REMARKS

DRAWING AMENDMENTS

ANNOTATED SHEET

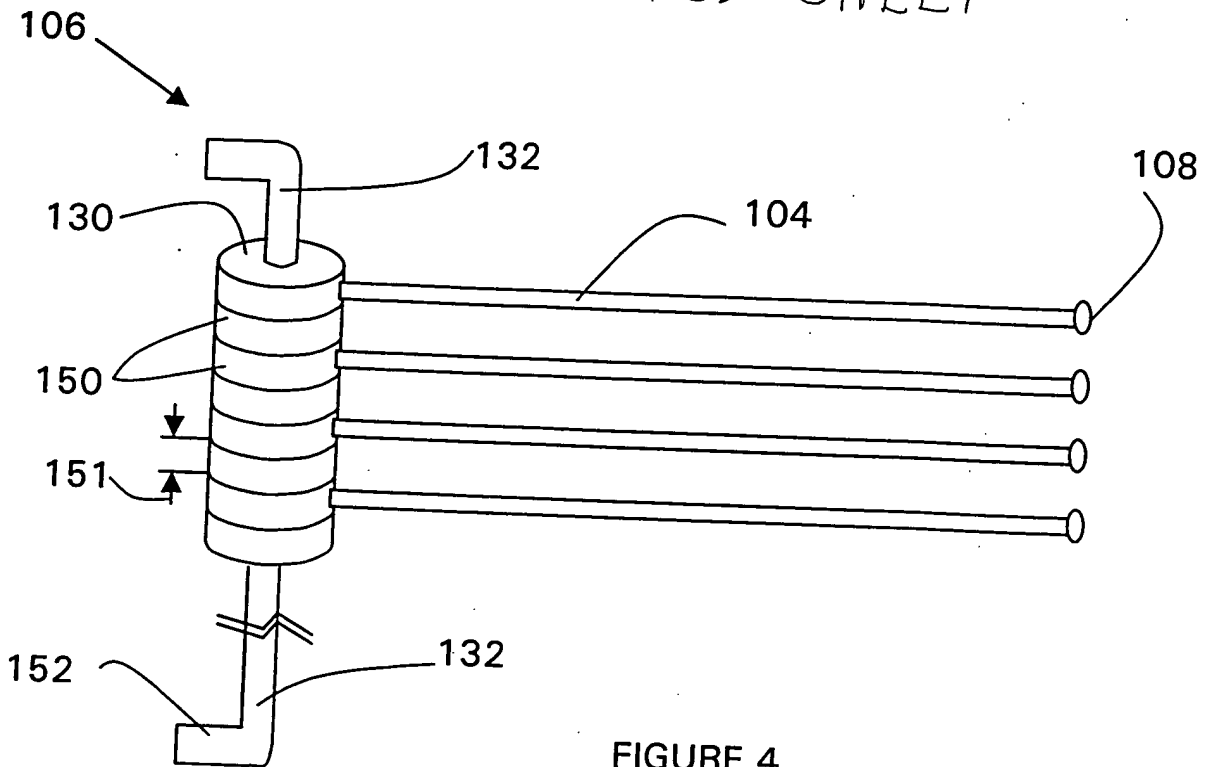
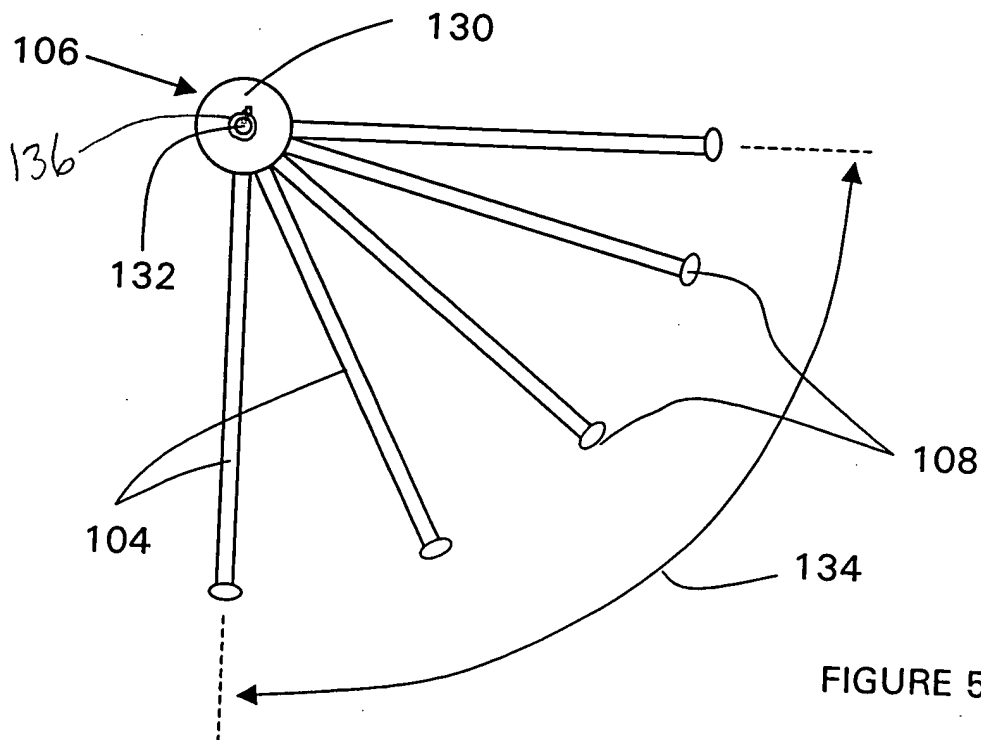
The Examiner has objected to the drawings as not showing the spring of claim 14. In response, Applicant has submitted a corrected drawing sheet showing the spring. Applicant has also submitted an annotated sheet showing the spring. No new matter is added.

The Examiner has rejected claim 14 as failing to comply with the enablement requirement because it is unclear how a spring is connected to the flag rods in order for it to return the flag rods to a designated position. In response, Applicant has amended the drawings and specification as above. Applicant submits that this rejection is thus overcome. No new matter is added.

Please replace the drawing sheet containing Figure 4 and Figure 5, with the attached Replacement Sheet.

Applicant has also attached an Annotated Sheet corresponding to the attached Replacement Sheet.
